FAA Control # 22-01-367

The KOLV ILS or LOC RWY 18 publishes a hold with time and distance, as shown in Figure 1; Figure 2 highlights the hold.

Figure 1. KOLV ILS or LOC 18.

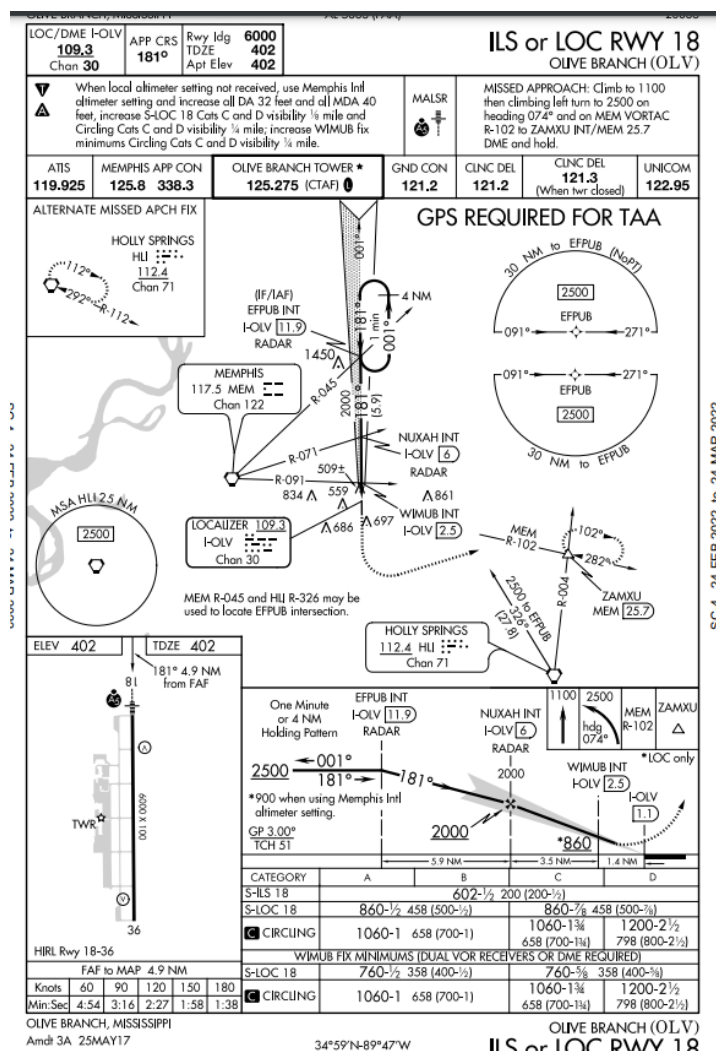
In response to an Aeronautical Inquiry to the FAA, the response indicated “the purpose of charting both, Timed Holding and Mileage Length, is to allow the aircraft pilot to choose which one they are capable of using based on the aircraft equipment available.” While this response is perfectly reasonable, the issue is there is no extant guidance the pilot can follow to make the choice (of course, all pilots are capable of doing timed holding).

If FAA is going to design procedures published with both time and distance holding, AIM guidance should guide the pilot on which to use.

Likely pilots will use distance as it is easier, but there should be guidance. Guidance will lower pilot cognitive workload.

Initial Meeting 22-01: Bill Tuccio, Garmin, briefed the item from the RD ([slide](#)), saying this happens seldom but is a pain for Garmin. The example slide for OLV ILS or LOC RWY 18 shows both time and distance for holding at EFPUB INT, and there is no clear guidance for which the pilot should use. Garmin did submit an aeronautical inquiry on this approach, and the response was the pilot can choose based on aircraft equipage. Bill inquired if AIM guidance exists or is needed for these. Steve Madigan, Garmin, said this is a problem, since there is no way to code both. Rich Boll, NBAA, said this is a conventional procedure (even though it has a TAA), and can be flown either way based on equipage and preference. Valerie Watson, FAA Charting Products Integration Team (AJV-A250), advised there used to be a number of dual holding procedures in the NAS, and in 2013 charting was given guidance from Brad Rush, (then with Aeronautical Information Services) that this was not correct and to only publish one or the other. On conventional procedures, timing was charted, and Valerie added there are only three of these procedures left in the NAS depicting both distance and time. Jeff Rawdon, FAA Flight Procedures and Airspace Group (FPAG), said there is no Order 8260.19 policy to provide both. Johnnie Baker, FAA Instrument Flight Procedures Group (AJV-400), suggested the response to the aeronautical inquiry sent by Garmin could have a more appropriate response, and took an IOU to revisit that inquiry. Valerie suggested to either add policy in Order 8260.3 to allow these, along with publication of AIM guidance, or to correct the remaining three procedures. Jeff thought correcting the remaining three would be preferable. Vince Massimini, general aviation pilot, added there are thousands of conventional procedures that have the one minute holding patterns, and agreed it would be best to remove the distance on the remaining three. Mark Mentovai, Manhattan Flight Club, said there is a human factors charting issue if there is a difference in the holding distance and/or time between the plan and profile views. Mike Stromberg, Independent Pilots Association (IPA)/UPS, agreed no changes to pilot guidance would be necessary if the three remaining procedures are revised. Dan Wacker, FPAG, said the reason for the 4 NM distance depiction is to support the TAA holding per Order 8260.19 and suggested the FAA needs to remove the TAA and go to conventional only, or change the criteria to support RNAV and conventional holding at the same fix on the hybrid procedures. Jeff added there is a question if timing is prohibited when distance holding is shown, and Dan thought it was and wants to look at the documentation policy. Rich said per Order

8260.19, the MSA and TAA should not be used on the same procedure as they are on this approach plate. Johnnie added on all conventional procedures timing should be used for holding. Diane Adams-Maturo, FPAG, talked about how hybrid procedures can have disconnects with criteria, and the FAA should take a closer look, especially concerning Order 8260.19 policy. John Collins, Foreflight, pointed out that some ILS approaches, with MSA and TAA information both charted, were broken into separate Y & Z procedures, and this procedure could have done the same. Dan said the existing criteria in Orders 8260.19 and 8260.3 is correct. In Order 8260.3, RNAV holding must use distance, and using both MSA and TAA on the same chart is not allowed.

Meeting 22-02: Jeff Rawdon, FAA Flight Procedures and Airspace Group (FPAG), briefed the item from the RD ([slide](#)). From the last meeting, AJV-A committed to revisiting the Garmin inquiry. There were only three procedures affected, and Pat Mulqueen, FAA Instrument Flight Procedures Group (AJV-400), committed that the IFP Group would review these procedures. The ACM Recommendation Review Group (ARRG) decided to not accept the issue for work since the scope was so limited and the IFP Group was committing to amending these procedures. Bill Tuccio, Garmin, asked if any criteria changes were necessary and Jeff confirmed the criteria was reviewed and no changes were determined to be necessary. Pat later confirmed the three procedures were planned for amendments and recommended closing the issue. Garmin concurred with closure of the issue.
